Access Compliance Report

Public Rights-of-Way

(Curb Ramps)

Intersection ID: 11110	Main Street: E_16TH_ST	Cross Street: N_TRYON_ST	Location: NW
ADA ID: 7647D26814EC	Ramp Type: Perp	Initial Pass/Fail: Fail	Overall Compliance: No
Severity Score: 12.5			
Codes/Mitigation Info/Possible Solution		Field Measurements/Component Compliance

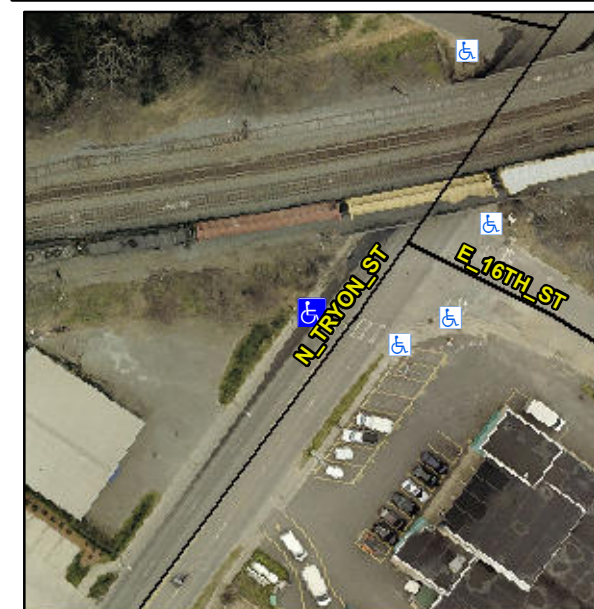
R304.2.2

Compliance	Description	Data	Compliance	Description	Data
N/A	Ramp Length (in)	64.0	No	Ramp Slope (%)	10.3
Yes	Ramp Width (in)	48.0	Yes	Ramp XSlope (%)	1.4
N/A	Flare Type LT	N/A	N/A	Flare Type RT	N/A
N/A	Flare Slope LT (%)	N/A	N/A	Flare Slope RT (%)	N/A
N/A	Flare Traversable LT?	N/A	N/A	Flare Traversable RT?	N/A
N/A	Landing Length (in)	N/A	N/A	DWS Provided?	N/A
N/A	Landing Width (in)	N/A	N/A	DWS Contrast?	N/A
N/A	Landing Slope (%)	N/A	N/A	DWS Length (in)	N/A
N/A	Landing X Slope (%)	N/A	N/A	DWS Full Width?	N/A
N/A	Landing Curb? (Y/N)	N/A	N/A	DWS Offset (in)	N/A
N/A	Shared Landing?	N/A			
N/A	Gutter Ponding?	N/A	N/A	Gutter Slope (%)	N/A
N/A	Gutter Lip Ht (in)	N/A	N/A	Gutter X Slope (%)	N/A
N/A	Painted X Walk1?	Yes	N/A	Painted X Walk2?	N/A
	X Walk 1 Direction	To SE		X Walk 2 Direction	N/A
N/A	X Walk 1 Width (in)	111.0	N/A	X Walk 2 Width (in)	N/A
	X Walk 1 Slope (%)	3.8		X Walk 2 Slope (%)	N/A
	X Walk 1 X Slope (%)	1.1		X Walk 2 X Slope (%)	N/A

Remove & Replace Entire Ramp.
